POLICY REPORT
DEVELOPMENT AND BUILDING

SUBJECT: CD-1 Rezoning: a) 2165-2195 West 45th Avenue and b) 2205-2291 West 45th Avenue; and Heritage Designation of the Ryerson Dunbar United Church

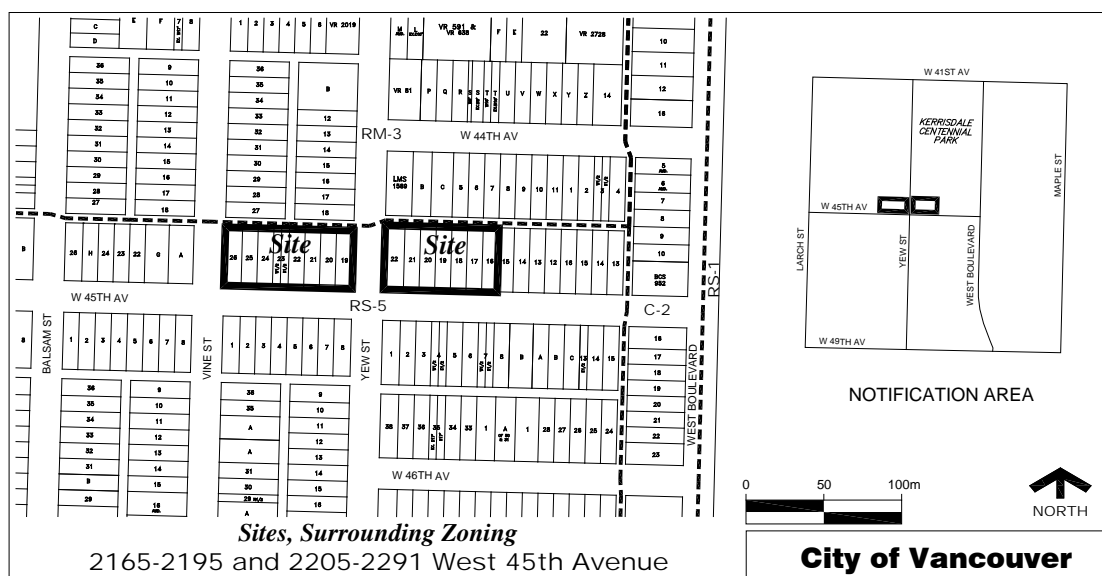
4. Setbacks should match single-family setbacks at east side:

A rezoning condition has been included for the row houses to match the setbacks of the adjacent single-family streetscape at the east side. The existing house to the east has a nonconforming side yard of 2 ft., noting that a 4 ft. side yard is required. The rezoning condition requires a 6 ft. setback on the subject property to offset the lesser setback at the single-family site, for a combined separation of 8 ft..
